Technical Guidance Committee Meeting

Minutes

Wednesday, January 30, 2013

Figure 4-20. Pump to drop box detail.

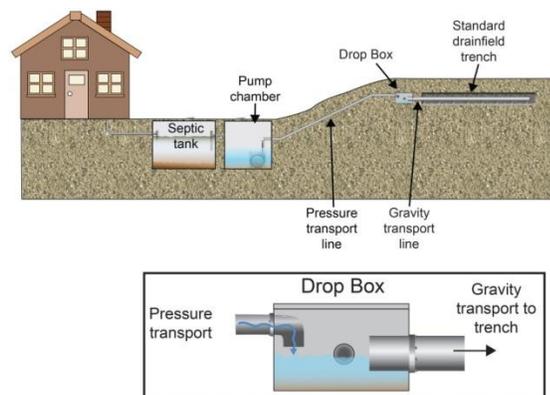
George Miles stated that item number 8 of this proposed section is an engineering function. George Miles stated that pump design is engineering and thus an engineer was needed to design this portion of the system. Without an engineer George Miles stated that the installer and homeowner were relying on computer programs that are not reliable. Discussion followed on how pumps need to be sized and selected for the best performance. The committee discussed the hundreds of pump to gravity systems that are in which were not designed by an engineer. Mike Reno voiced concern over requiring a homeowner to get an engineer to design a pump to potentially lift effluent over very short runs and with little vertical lift. The committee decided that engineering should be recommended under certain conditions which were added to the section. The committee also added the statement that the pump selection is recommended to be performed by an engineer licensed in the State of Idaho.

The committee did not like the proposal of the use of a check valve in the system design. This portion of the proposed section was removed.

7. The pump to drop box system design may require engineering based upon the regulatory authority's judgment. Pump design should be performed by an engineer licensed in the State of Idaho when elevation gains of greater than 20 feet or lengths of 100 feet are exceeded in effluent transport.

Figure 3-3. Overhead view of equal distribution methods.

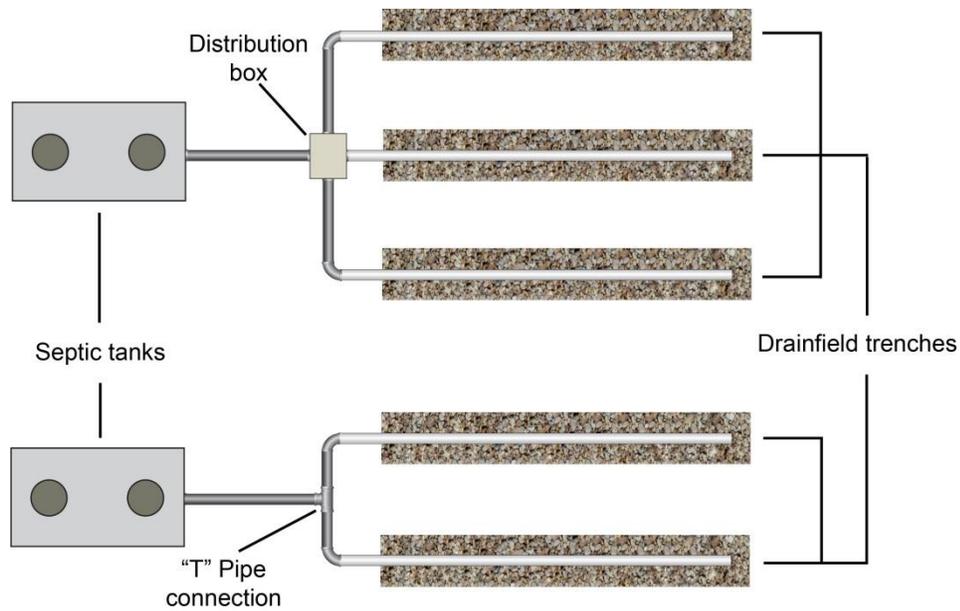
The proposed additions of these sections were at the request of the committee. The material used to develop these sections was derived from the EPA Onsite Wastewater Treatment Systems Manual as requested by the committee. The committee made some recommendations to limit the use of serial distribution and asked that the figure under the piping header section be changed to two trenches instead of 3.

With a piping header system wastewater is conveyed to each disposal trench through the use of a network of solid piping. The discharge line from the septic tank should be split through the use of a T pipe fitting. The T should be offset equally from the distribution trenches. One-directional sweeping cleanouts should not be used in place of a bi-directional T. It is recommended that the piping header only be utilized in installations involving two trenches. See figure 3-3 for an overhead view of this distribution setup.
